Broadmeadow Estuary Greenway ABP Submission July  
2019 - ABP Reference PL06F.304624

Extract from Drawing 12-160-256

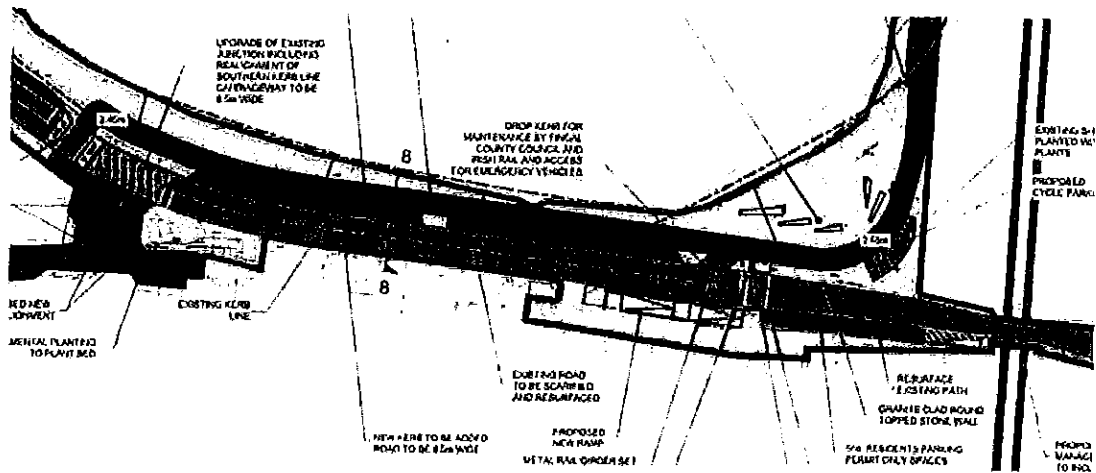
The most disappointing aspect of the Bissetts Strand proposed design is the proposed increase in car parking in the area, while limiting the width of the proposed greenway track, and without any buffer proposed between the proposed parked cars and the greenway. This can be seen directly in the images below from

As the 'before' and 'after' images clearly demonstrate, priority in the design of this proposed greenway has clearly been given to car usage, and not to greenway usage. This is unacceptable.
